1. 462-7.4.2.1.4(4620000 POST-TENSIONING
COMMENTS FROM INTERNAL/INDUSTRY REVIEW

2. 462-7.4.2.1.4.3(2)(a) Vacuum Wax Injection:

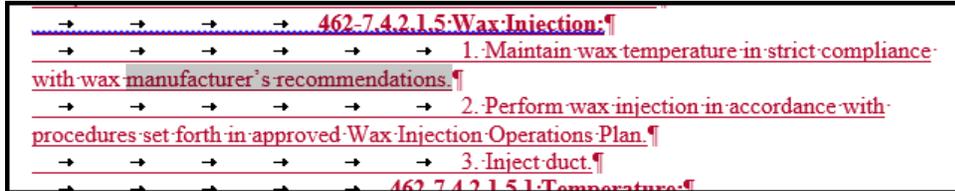
This rating will be pressure specific. For example, a pump may be rated for 10 ft3/min at 10 psia but only 5 ft3/min at 5 psia and each pump will have a pump curve relating power and operating conditions. Should this be accounted for in the previously stated requirement?

4. 462-7.4.2.1.6 Manufacturer's Installation Technician:

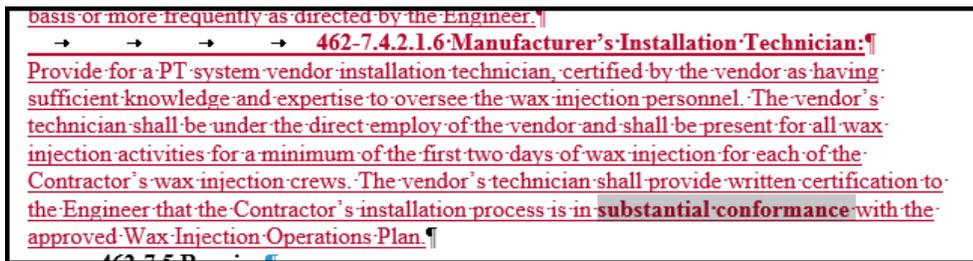
Is substantial conformance good enough? Why not complete conformance?
